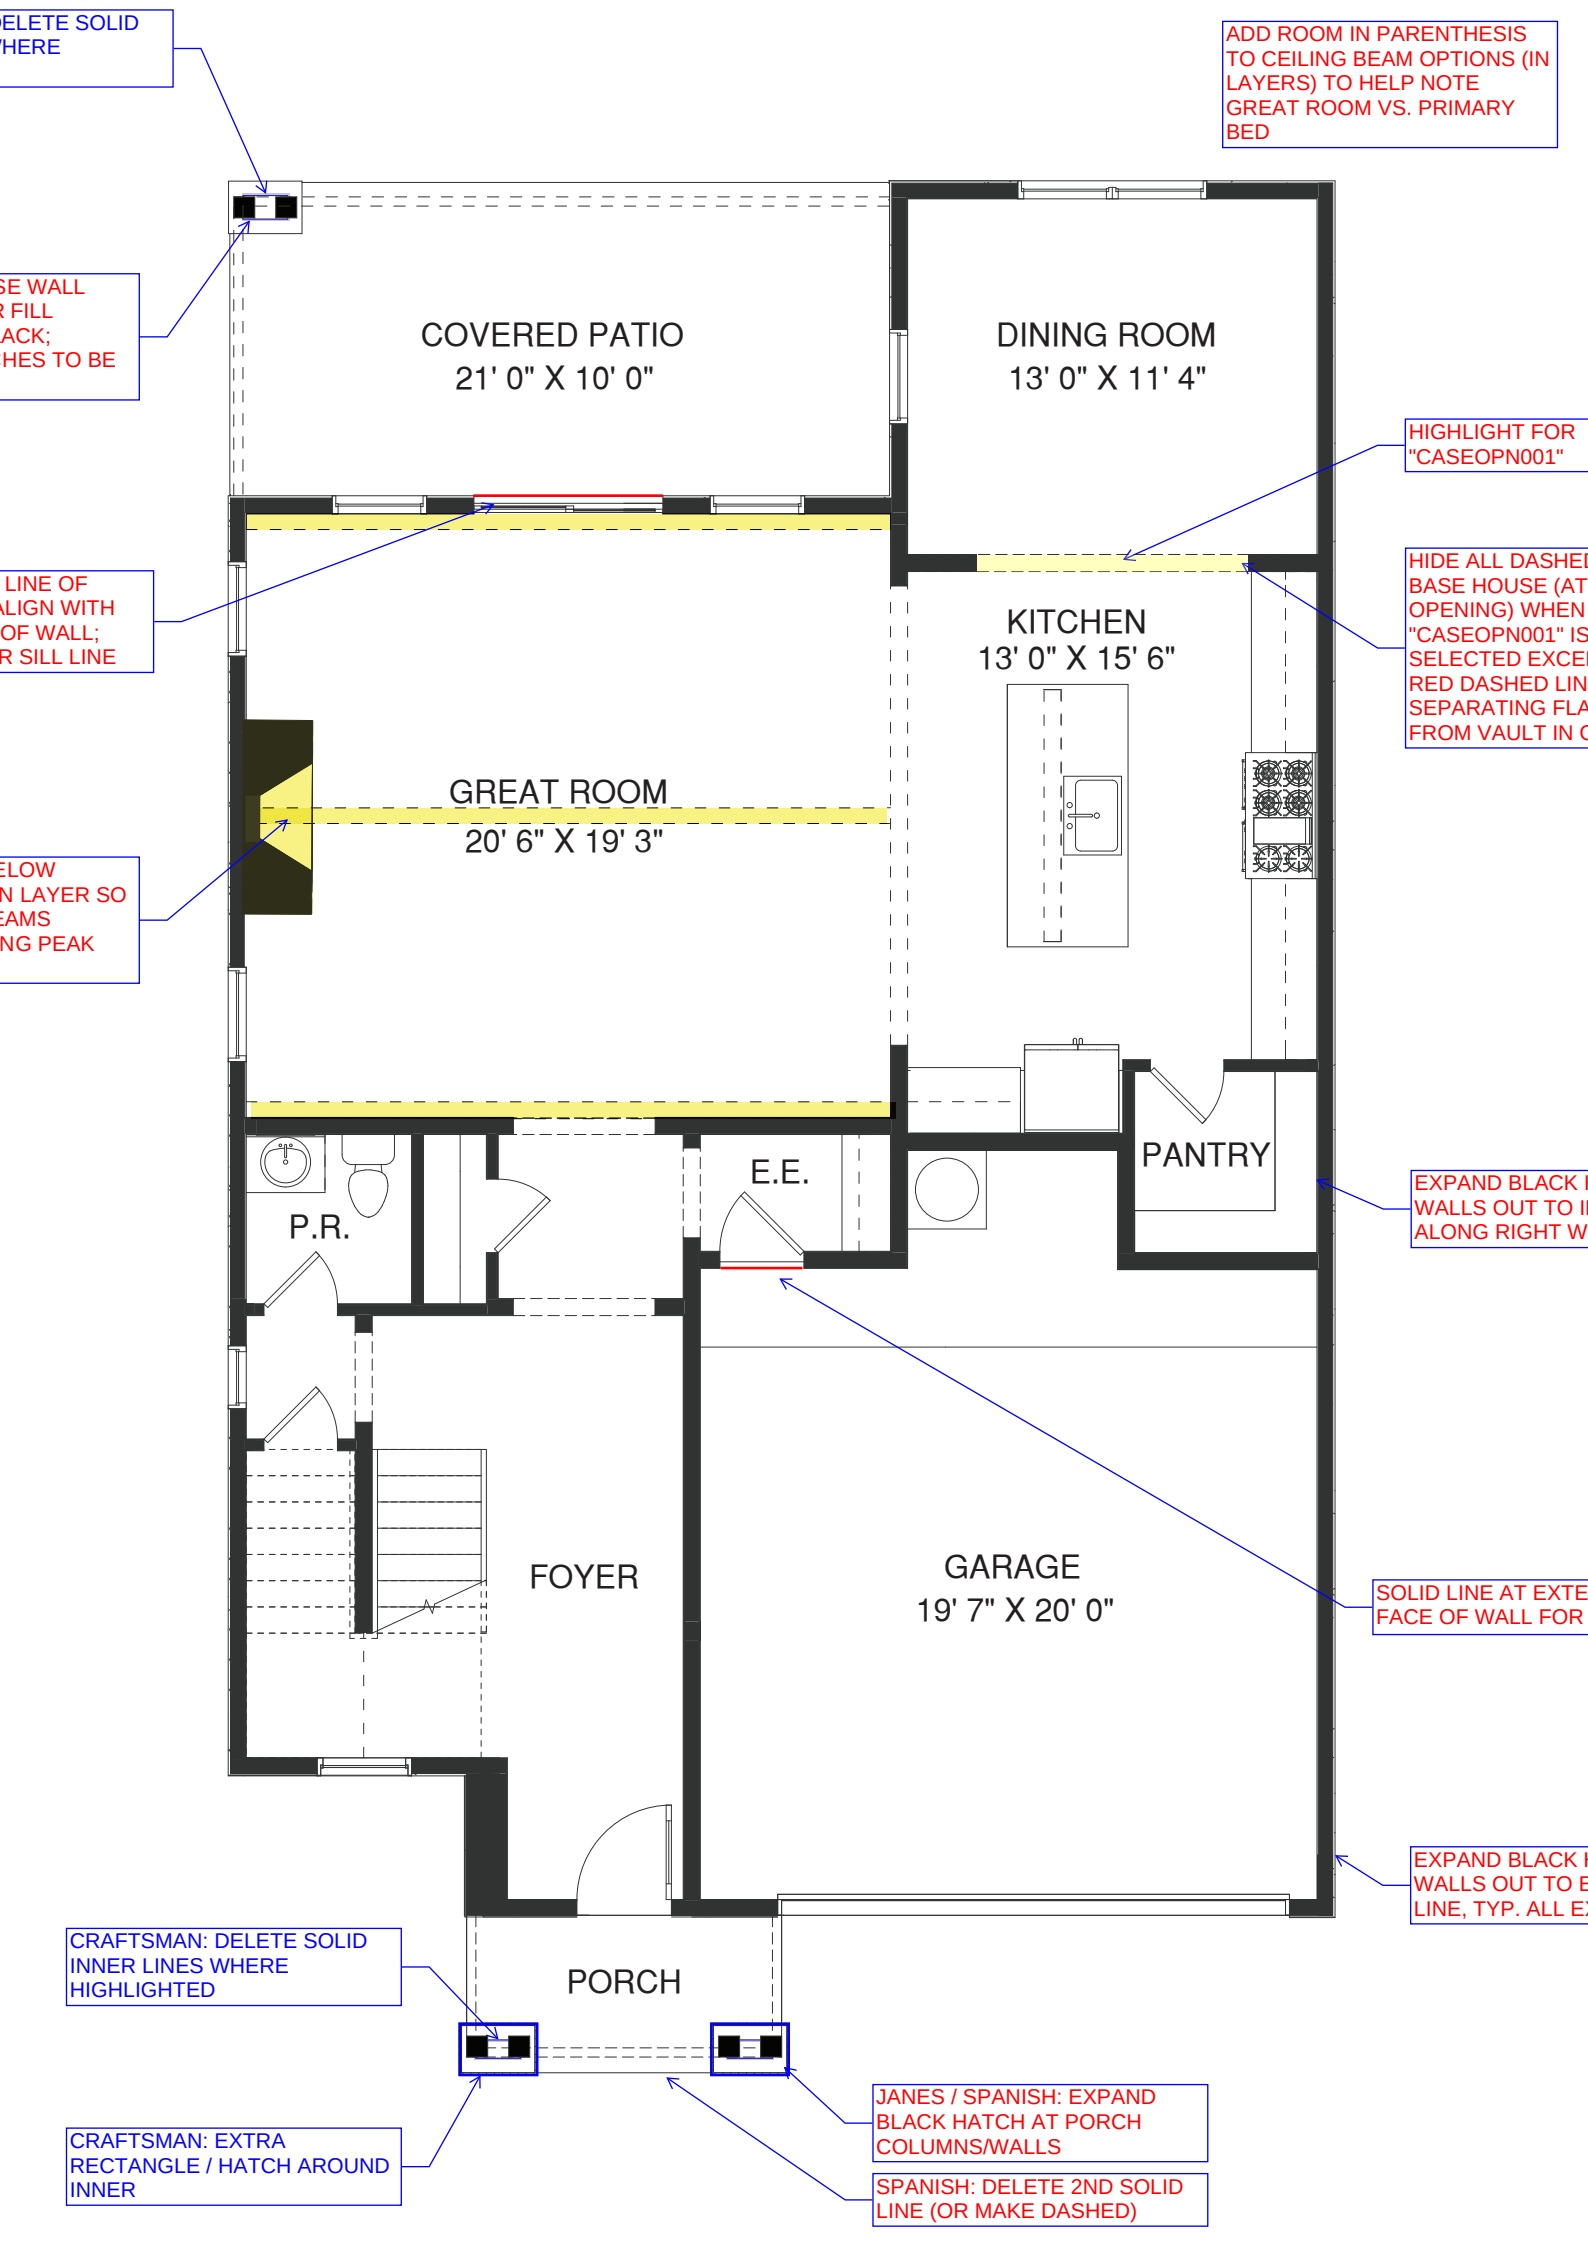
IT LOOKS LIKE BASE WALL
HATCH AND INNER FILL
REGION IS NOT BLACK;
UPDATE ALL HATCHES TO BE
BLACK

ADD ROOM IN PARENTHESIS
TO CEILING BEAM OPTIONS (IN
LAYERS) TO HELP NOTE
GREAT ROOM VS. PRIMARY
BED

NOT SURE HOW OVERLAPPING
HIGHLIGHTS APPEAR IN
CHECKOUT WITH MULTIPLY;
LET'S FOLLOW UP WHEN
THESE ARE UPLOADED TO
SEE IF THIS APPEARS OKAY.

HIGHLIGHT FOR "BED001"
APPEARS DARKER THAN
OTHERS; CONFIRM THAT ALL
HIGHLIGHTS ARE MULTIPLY VS.
HAVING TRANSPARENCY PER
TECHS' ASK

"BED001" TURNS SOMETHING
ON IN THE LAUNDRY (AND
MAYBE PRIMARY BATH?).
ISOLATE DOWN TO THE
BEDROOM AREA ONLY

EXPAND BLACK HATCH IN
WALLS OUT TO EXTERIOR
LINE, TYP. ALL EXT. WALLS

DASHED LINES
SOLID LINES
(GHOSTING)
